09 - 2011
BCL180Z / BCL180F
18V VACUUM CLEANER

SERVICE CHANGES

1. Changes on Sponge Sheet

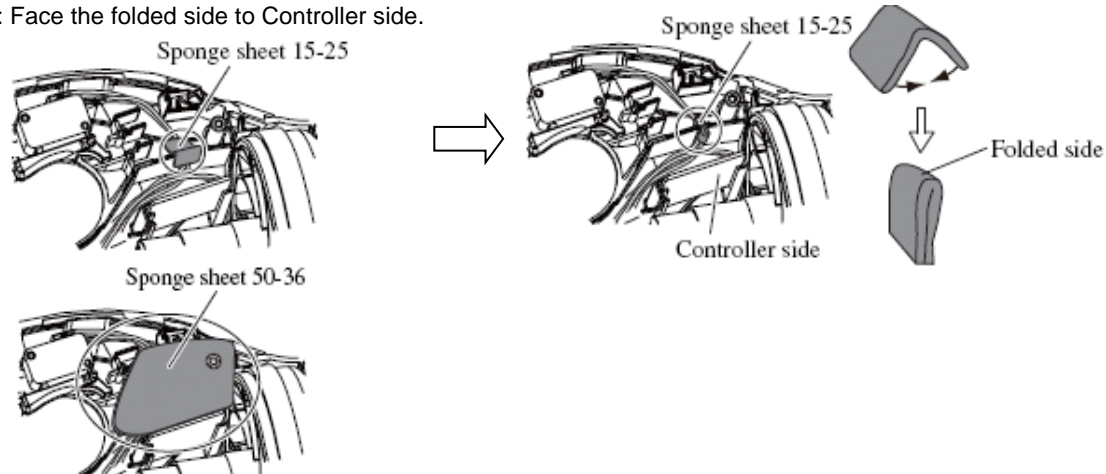
Item No.	Description	Type 1	Type 2
8	SPONGE SHEET 15-25		424248-4
22	SPONGE SHEET 50-36	-----	424308-2

Above parts are completely interchangeable as a set.

After putting these lead wires into the bottom of lead wire holder, insert a folded Sponge sheet 15-25 so that the sponge sheet's height and the ribs' height are in a line as illustrated above.

Note: Face the folded side to Controller side.
